SUPPLEMENTAL INFORMATION
ADDENDUM NO. 1

PROJECT: ITB 21-55-001A
Civil/Site Work for Fire Station No. 15 – Hodgeville Road

DATE ISSUED: September 9, 2020

8	BOLLARD DETAIL
A3.3	3/4" = 1'-0"

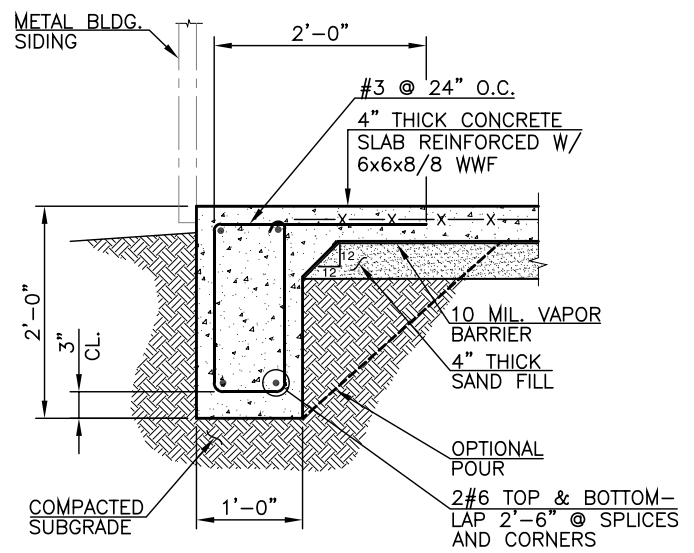
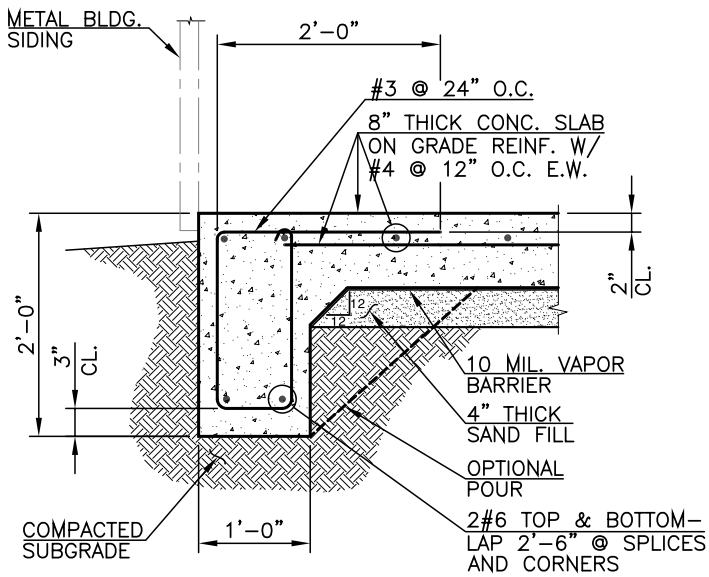
- 1) QUESTION: Can you provide a detail for the (4) bollards in the concrete paving?
ANSWER: Please see attached detail.
- 2) QUESTION: Can you provide details for the header curb and 3' concrete flumes? ANSWER:
Please see attached details.

- 5) QUESTION: Who is responsible for the sidewalk at the rear of the building, site contractor or building contractor?
ANSWER: Site Contractor
- 6) QUESTION: Who is responsible for the bollards at the roll up doors, site contractor or building contractor. If it is the site contractor could you please provide a detail for the bollards?

ANSWER: site contractor; please see attached detail.
- 7) QUESTION: Who is responsible for the final stabilization (grassing), site contractor or building contractor?
